**TOWN PLAN AND ZONING COMMISSION  
GLASTONBURY, CT  
APPLICATION FOR SPECIAL PERMIT**

**STAFF REPORT**

**Proposal:**  
Section 12 Special Permit with Design Review: Conversion of Residential Hom to Office with Addition

# Architectural & Site Design Review Committee Report

PRELIMINARY SITE PLAN  
#148 OAK STREET  
PREPARED FOR  
DELPONTE PLUMBING  
GLASTONBURY, CONN.

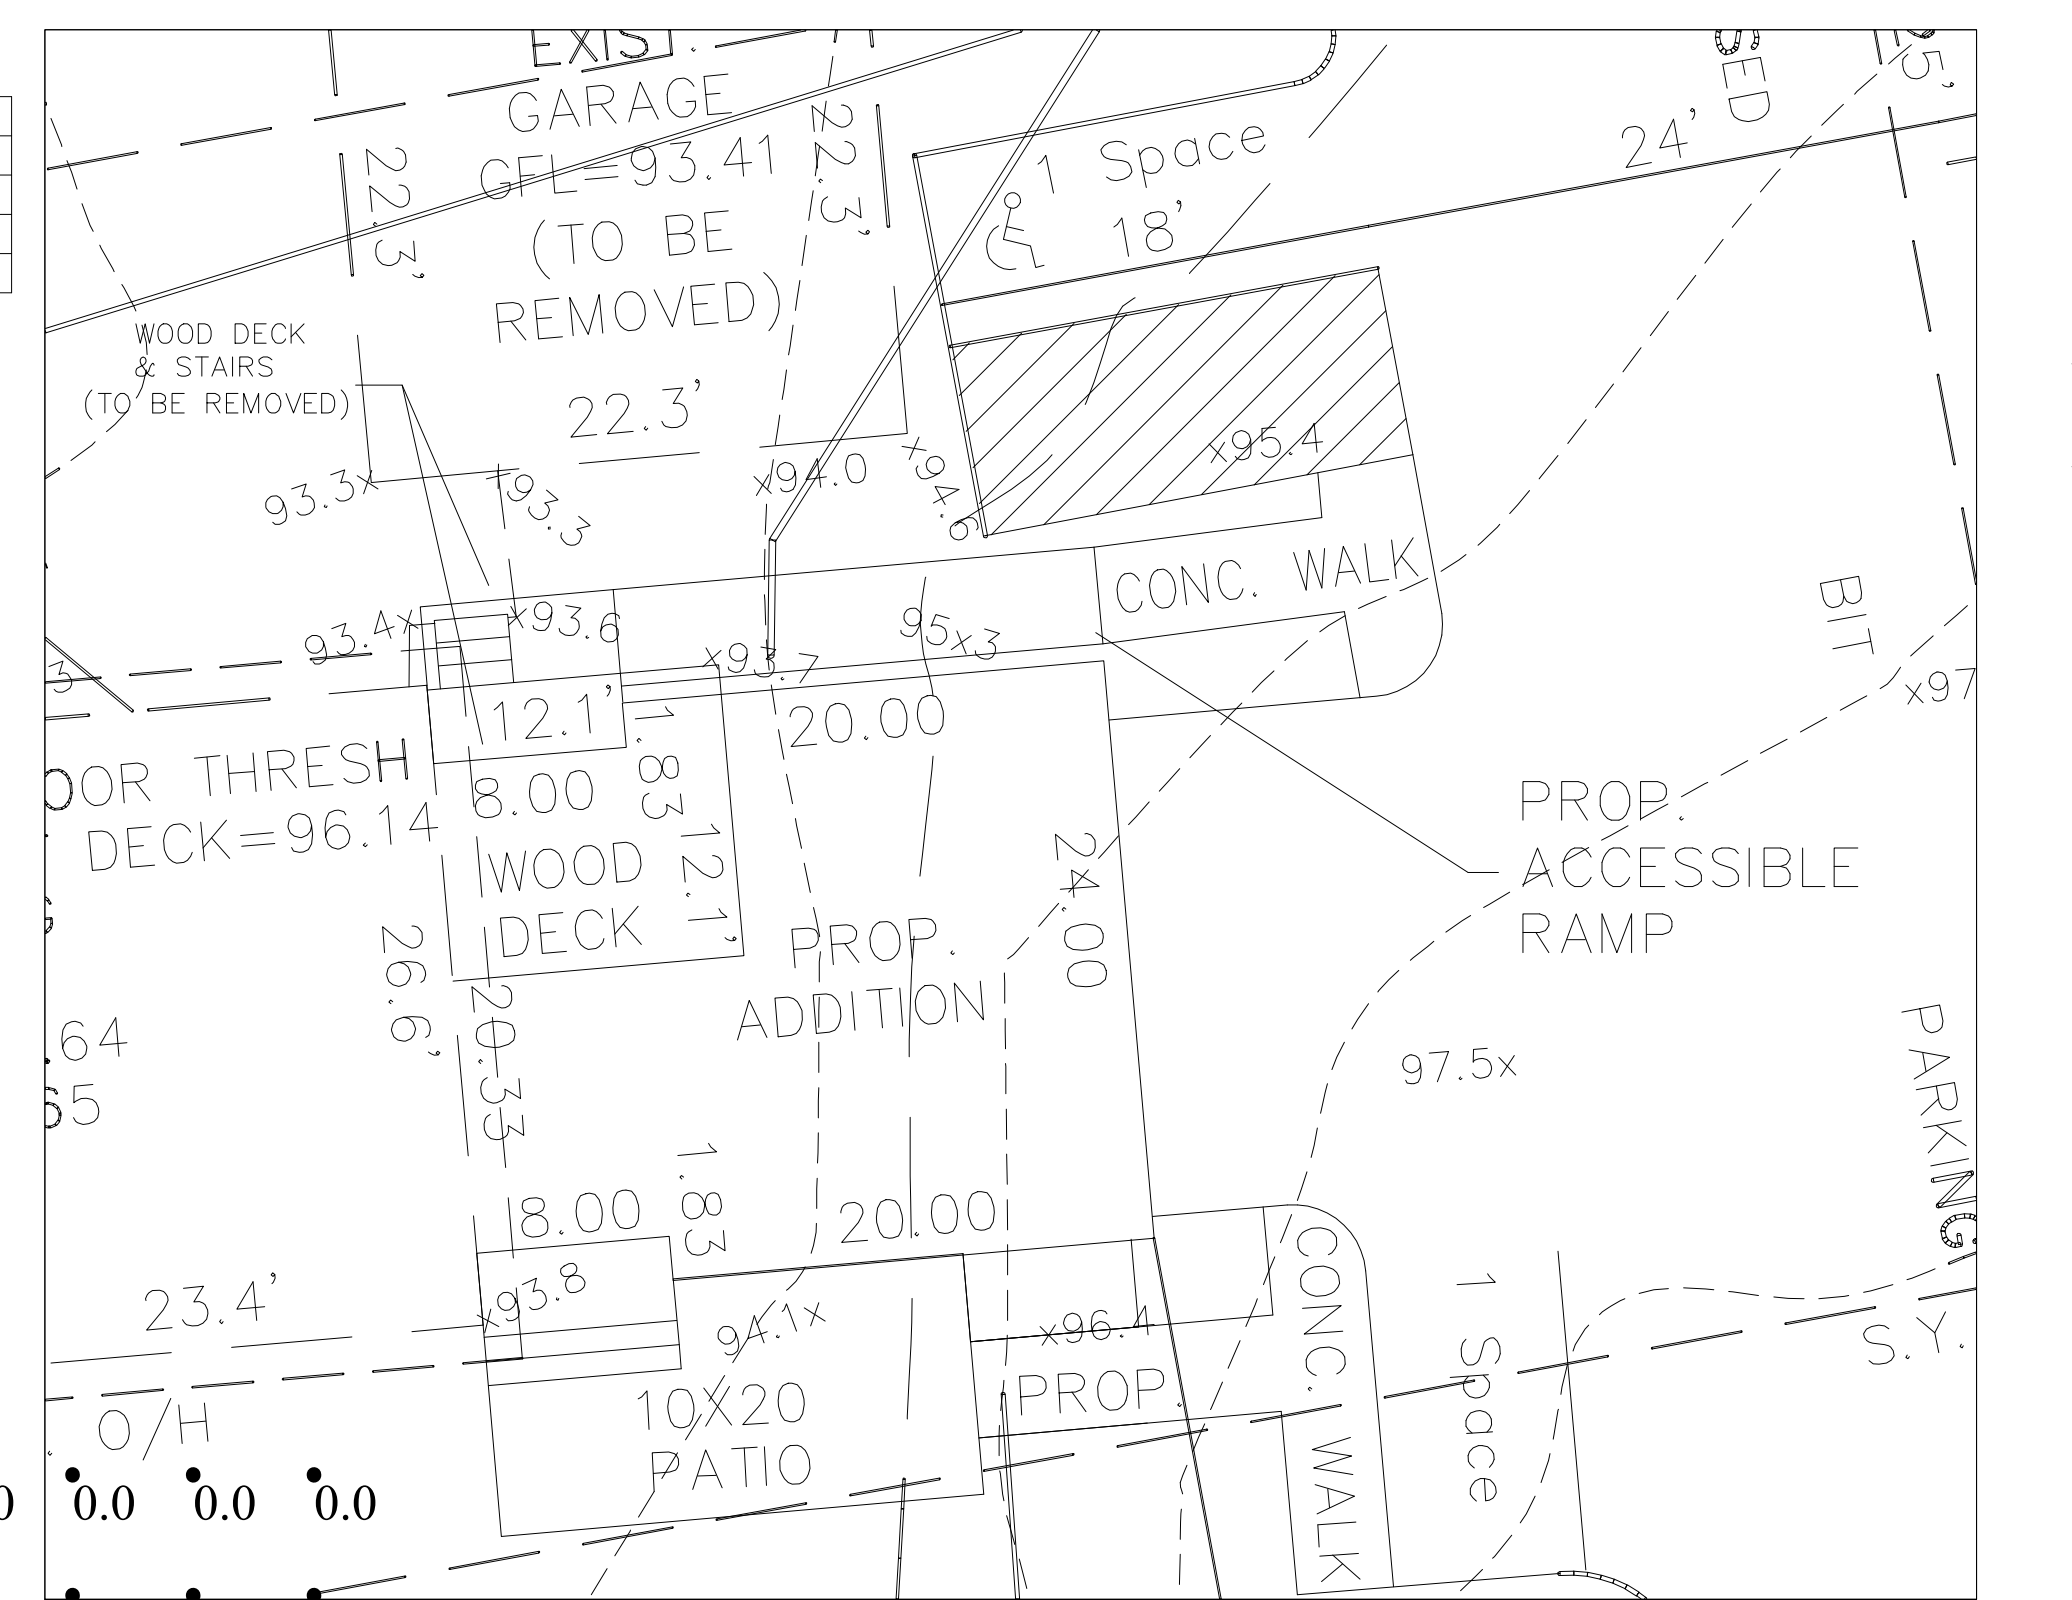
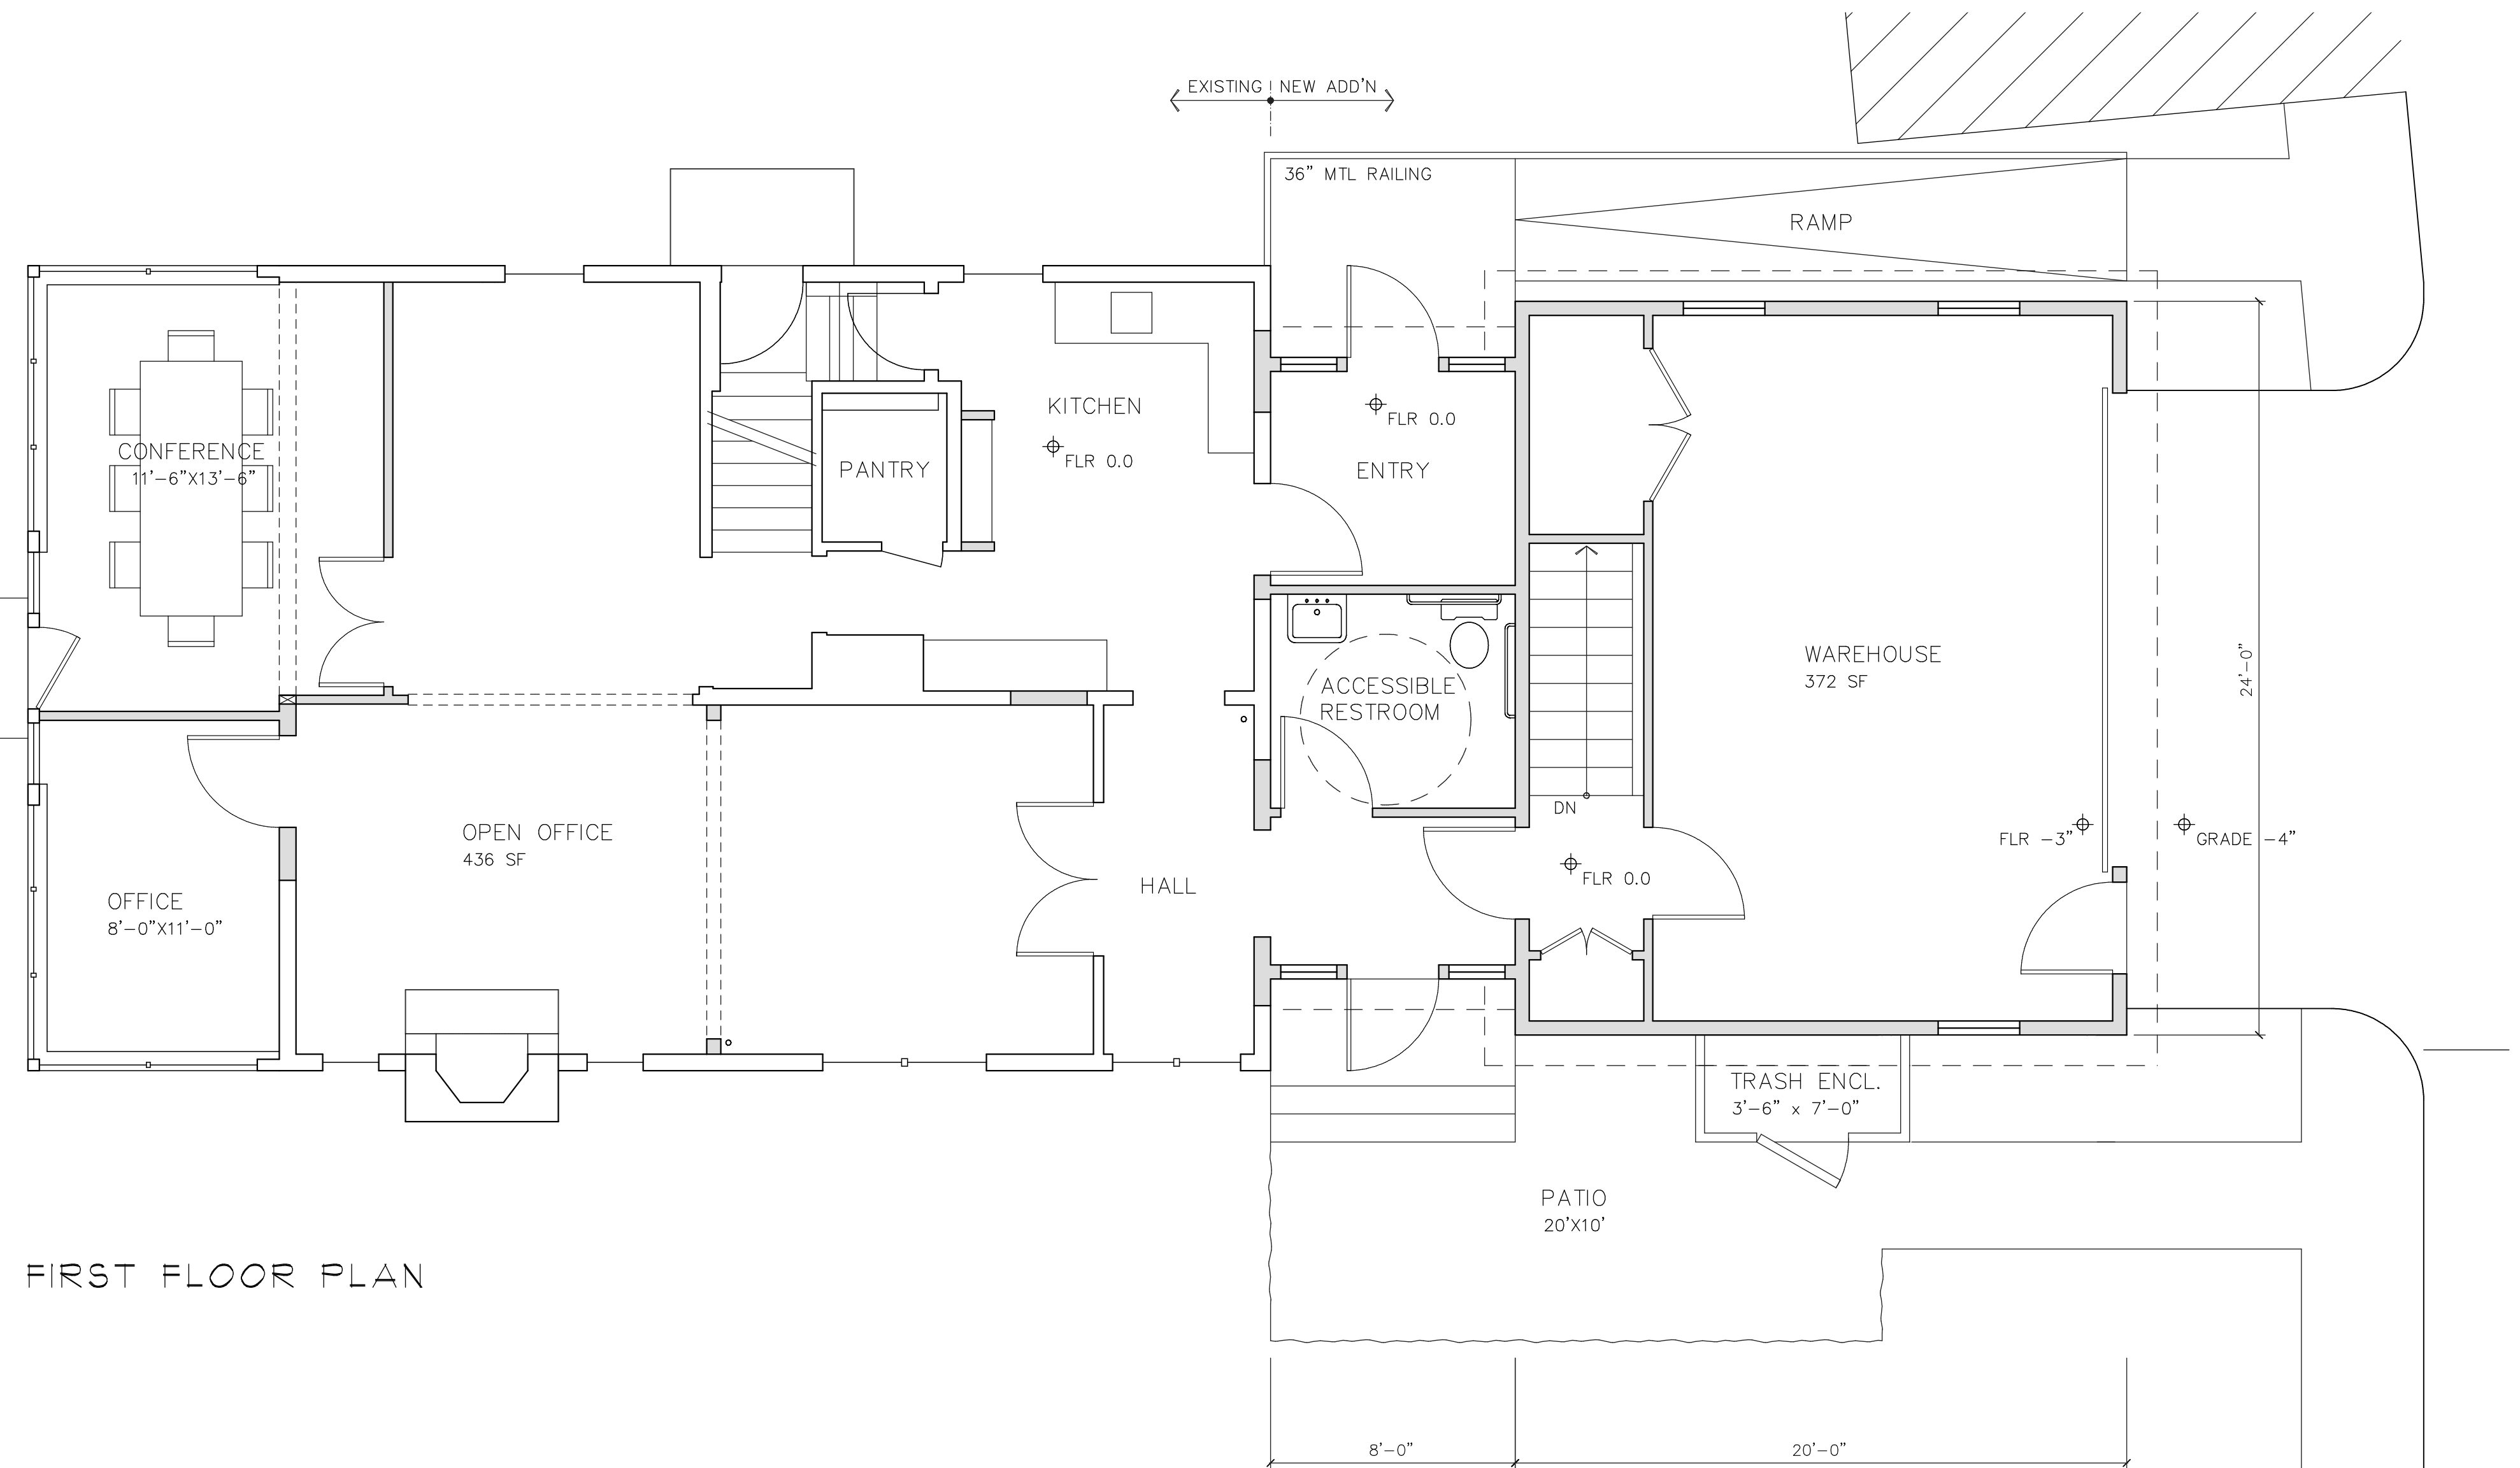
- Per ASDRC request revise driveway width to 16ft wide as approved by Department of Engineering and the Fire Marshal Office.
- **Revise sign plan for detached sign as follows: Remove two "blank sign panels, Lower sign height to no more than 6ft high, Add landscaping to the base of detached sign, Measure sign area by a single rectangle in which the text fits into.**

- **Remove or reduce size of wall sign. (By Special Permit TPZ has the authority to reduce sign area)**
- **In the landscape island adjacent to handicap parking space replace Little Blue Stem with a shade tree.**

- Relocate light pole in landscape island adjacent to handicap parking space to north side of driveway.
- **Revise elevations and architectural drawings to include 6 over 1 mutton bars on the windows. (at minimum shall be added to windows on front elevation).**

- Add note to lighting plan all exterior lighting will be shut off and turned on 30 minutes prior to opening and closing of business operations, except for necessary security lighting.

- Submit revised lighting plan to be approved administratively by ASDRC as the lighting plan is too bright and has "hot spots" going from 9-foot candles to .3-foote candles. Lighting plan submitted shall meet IES recommended standards.

- Revise landscape plan on southern property boundary to strategically place no larger than 5-gallon containers of viburnum to be installed, using ANSI Tree, Shrub, and Other Woody Plant Management-Standard Practices to help protect root system of mature maples.

NOTE: ALL EXTERIOR LIGHTING WILL BE SHUT OFF AND TURNED ON 30 MINUTES PRIOR TO OPENING AND CLOSING OF BUSINESS OPERATIONS, EXCEPT FOR NECESSARY SECURITY LIGHTING.
